Service Update

17069 Auxiliary Coolant Pump to Transmission Fastener Attachment

Reference Number: N162077350

Make	Model	Model Year		RPO	Description
		From	To		
Chevrolet	Malibu	2017	2017

4705856

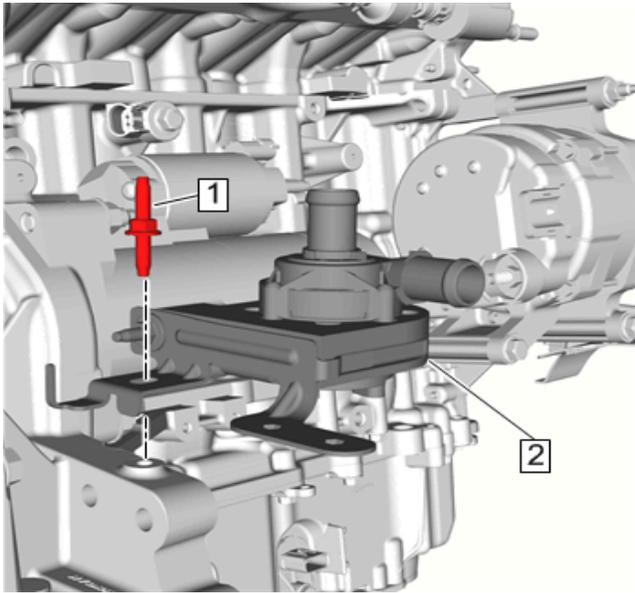
Condition	The counter bore in the torque converter housing used for auxiliary coolant pump attachment was drilled deeper than specification. The increased counter bore depth limits the usable thread distance for the original fastener to contact. There is only one fastener used to hold the pump.
Correction	Replace the double ended auxiliary coolant pump mounting stud with revised attachment bolt.

3. Remove the heater coolant pump bracket bolt (1).

Note: The new heater coolant pump bracket bolt has a hex head and is NOT a double ended stud.

4. Install a new heater coolant pump bracket bolt and torque to 9 Nm (80 lb in).
5. Remove fender covers and close hood.
